Sensitivity Studies

2.5.2.3 Technical Evaluation

Figure 2.5.2-7 Regional seismicity for ESP site

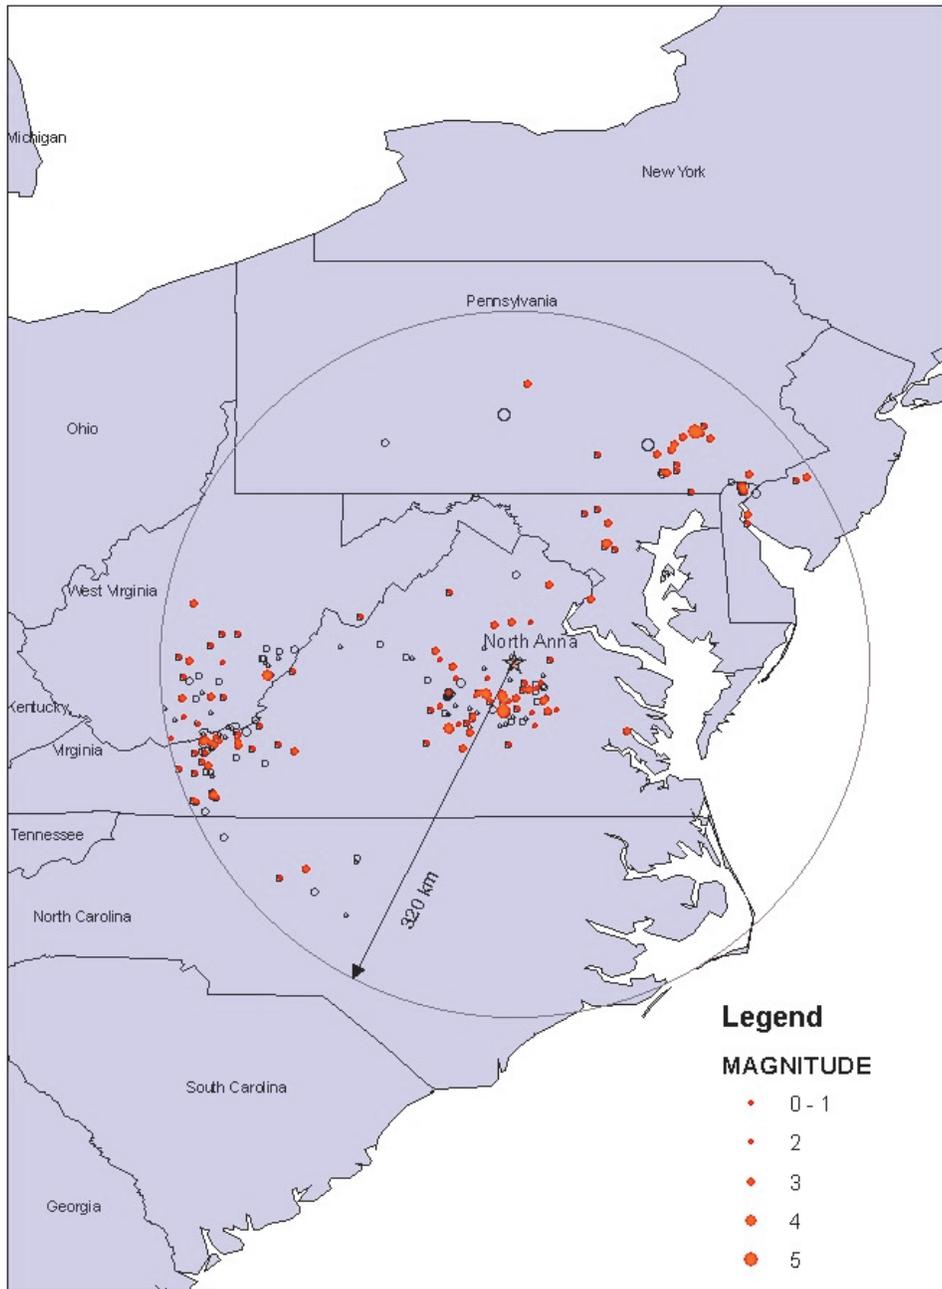
The staff reviewed both the original EPRI seismicity catalog and the update to the catalog. The applicant added 30 more earthquakes to the regional catalog for the ESP site. Figure 2.5.2-7 depicts the earthquake epicenters in the region surrounding the ESP site. The more recent events since 1984 are shown as solid dots. The cluster of seismicity to the south-southwest of the ESP site is from the CVSZ.

Because the applicant used the EPRI seismicity catalog, which is part of the 1989 EPRI seismic hazard study that the NRC endorsed, the staff concludes that the seismicity catalog used by the applicant is complete and accurate through 1984. The staff compared the applicant's update of the regional seismicity catalog with its own listing of recent earthquakes and did not identify any significant omissions. Accordingly, the staff concludes that the applicant accurately updated the regional seismicity.

Figure 2.5.4-3 Locations of previous boreholes

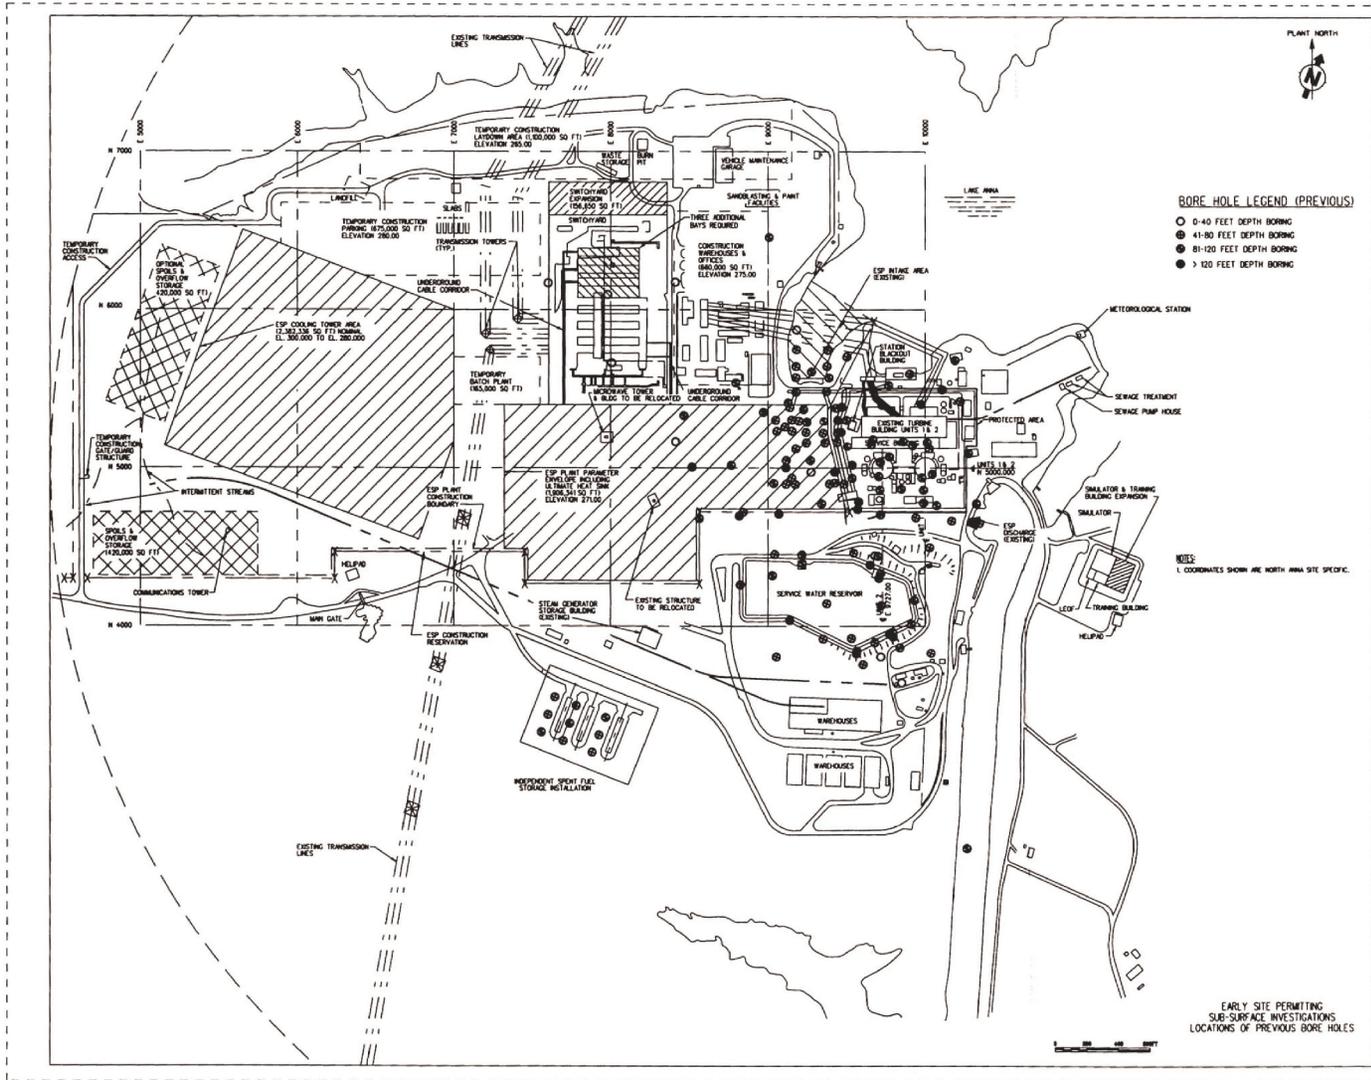
In RAI 2.5.4-1, the staff asked the applicant to provide its basis for concluding that the subsurface conditions in the southeast portion of the ESP footprint (an area of about 500 ft by 1000 ft, in which there are no borings) do not materially differ from conditions in adjacent areas where borings were made. In its response, the applicant stated that the North Anna site is underlain by a consistent geologic profile, which extends to a depth of several thousand feet. The 145 borings performed throughout the North Anna site (including 7 for the ESP) indicate a consistent overall subsurface profile, with expected variations in the thickness of the various strata. As such, the applicant concluded that the southeast portion of the ESP footprint (see SER Figure 2.5.4-3) should be similar to the rest of the site.

Figure 2.5.4-5 Variation of normalized shear modulus with cycle shear strain

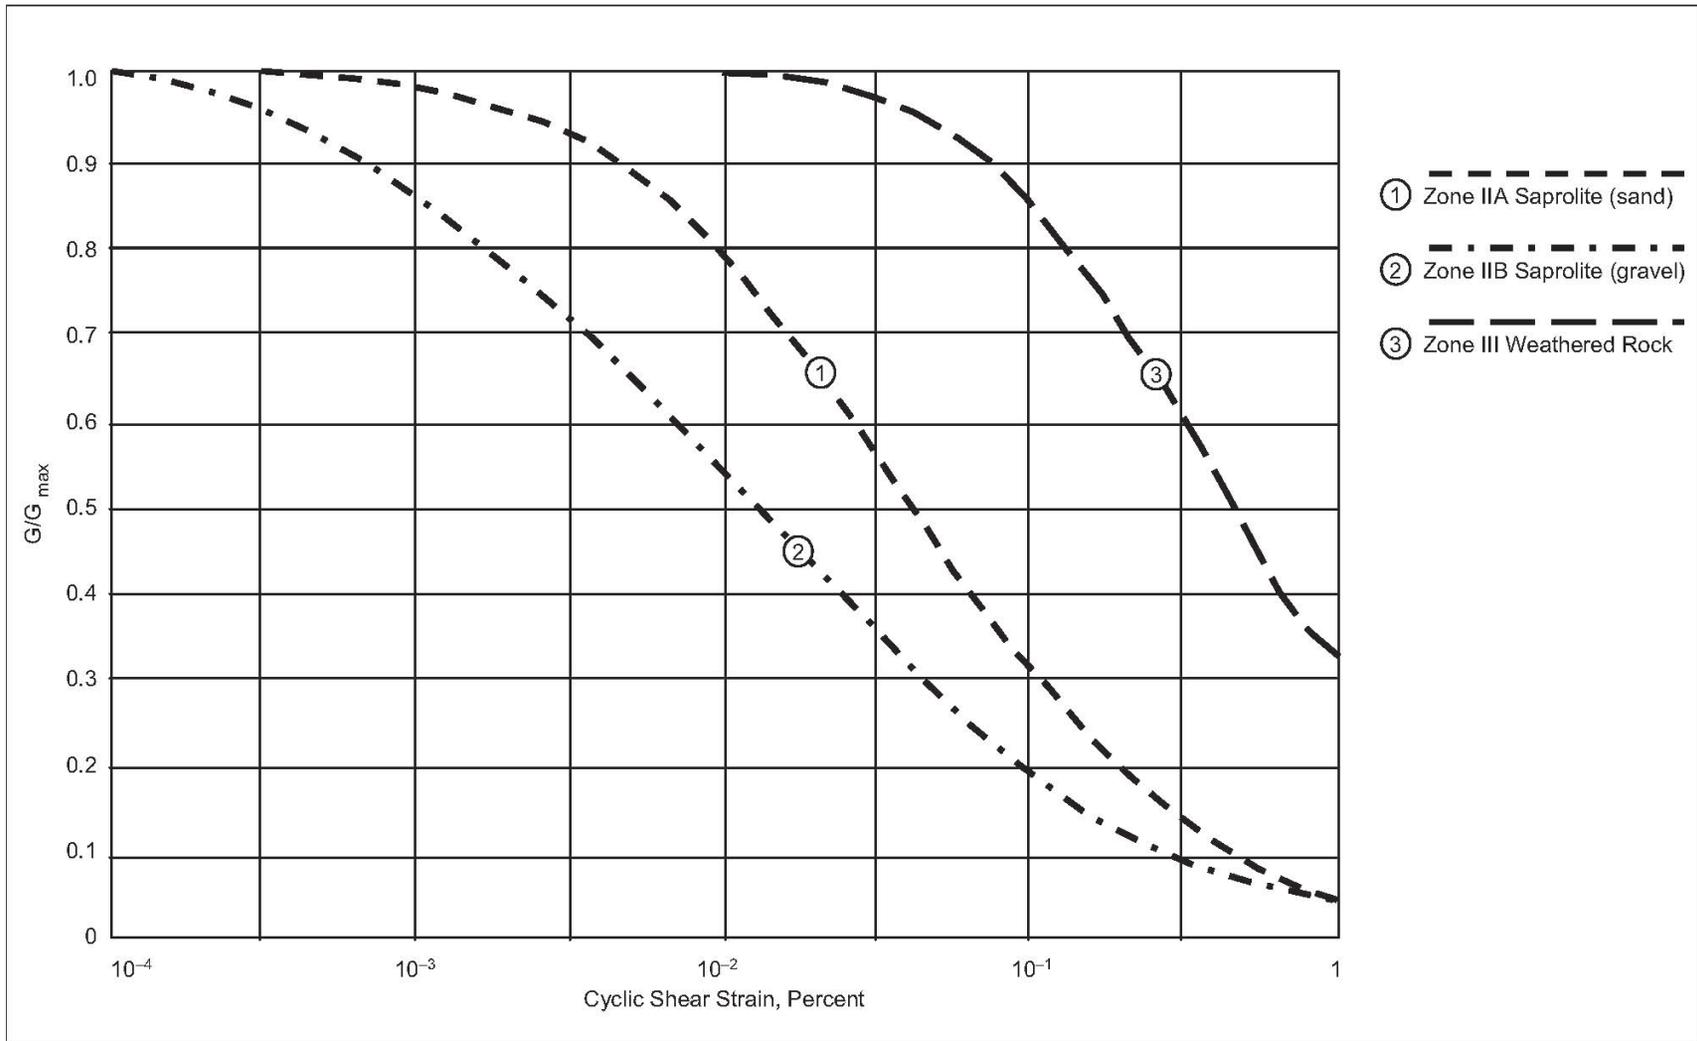
In RAI 2.5.4-8, the staff asked the applicant to provide its basis for the selected modulus reduction and damping ratio curves for Zones IIA, IIB, and III. In its response, the applicant stated that it used the 1993 EPRI report (Ref. 170, SSAR Section 2.5), where applicable, as the basis for the shear modulus reduction and damping ratio curves.

In RAI 2.5.4-8, the staff asked the applicant to provide its basis for the selected modulus reduction and damping ratio curves for Zones IIA, IIB, and III materials. In response to RAI 2.5.4-8, the applicant stated that it used the 1993 EPRI report (Ref. 170, SSAR Section 2.5.2), where applicable, as the basis for the shear modulus reduction and damping ratio curves. The staff reviewed the curves that the applicant selected for each of the soil and rock zones to determine whether the applicant based its selection on appropriate criteria, such as grain size, cohesiveness, confining pressure, and shear wave velocity. The staff concludes that the shear modulus and damping curves selected by the applicant were based on appropriate criteria and are suitable for Zone IIA, IIB, and III soil and rock.

Figure 2.5.4-6 Variation of damping ratio with cyclic shear strain

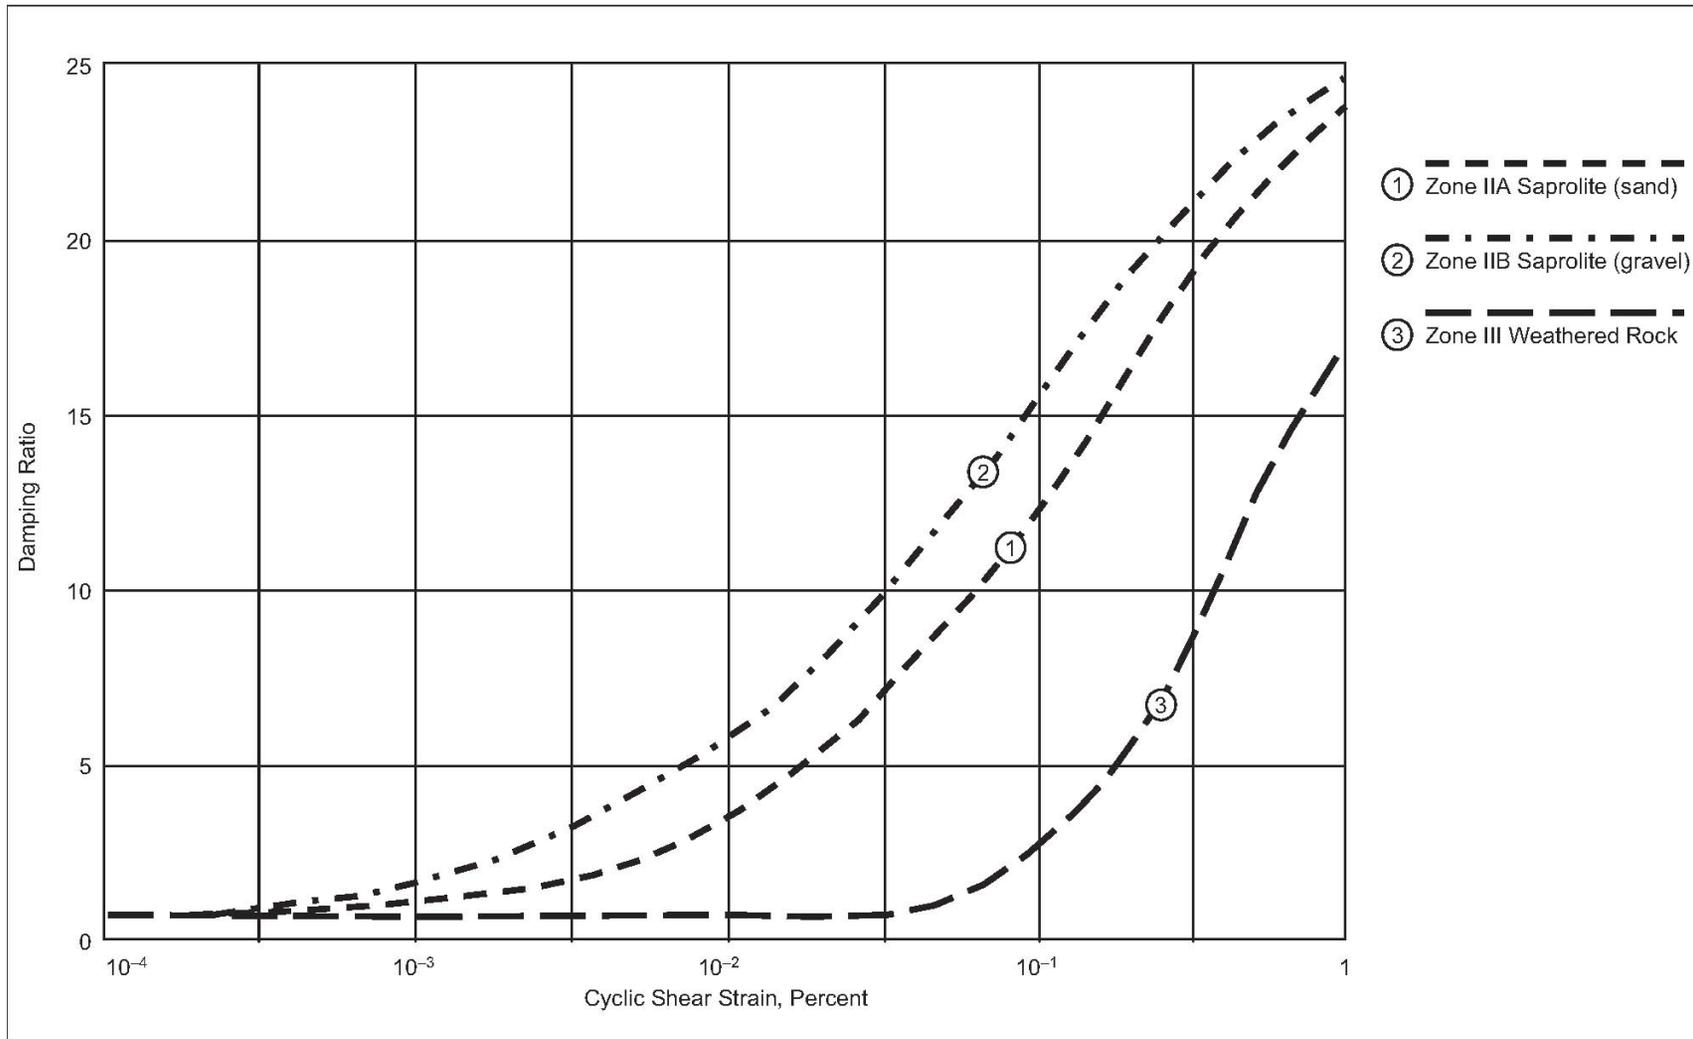
In RAI 2.5.4-8(c), the staff asked the applicant to explain its use of a damping ratio of 2 percent for the Zone III-IV rock. In its response, the applicant stated that the damping ratio for rock varies from site to site depending on the various factors, including the mineral composition of the rock, the integrity and fissuring of the rock mass, and the level of shear deformation in the rock formation. According to the applicant, damping ratios for rock are generally between 0.5 to 4.5 percent. The applicant selected 2 percent for the Zone III-IV rock based on engineering judgment and past experience. To determine the sensitivity of the selected damping ratio, the applicant reran its analysis using damping ratios of 0.5, 1.0, and 5.0 percent. The results show only a slight difference in the peak acceleration for the different damping ratios.

In RAI 2.5.4-8(c), the staff asked the applicant to explain its use of a damping ratio of 2 percent for the Zone III-IV rock. In response to RAI 2.5.4-8(c), the applicant stated that the damping ratio for rock varies from site to site depending on various factors, including the mineral composition of the rock, the integrity and fissuring of the rock mass, and the level of shear deformation in the rock formation. According to the applicant, damping ratios for rock are generally between 0.5 to 4.5 percent. The applicant selected 2 percent for the Zone III-IV rock based on engineering judgment and past experience. To determine the sensitivity of the selected damping ratio, the applicant reran its analysis using damping ratios of 0.5, 1.0, and 5.0 percent. The results reveal only a slight difference in the peak acceleration for the different damping ratios. Based on these results, the staff concludes that a damping ratio of 2 percent for the Zone III-IV rock is acceptable.
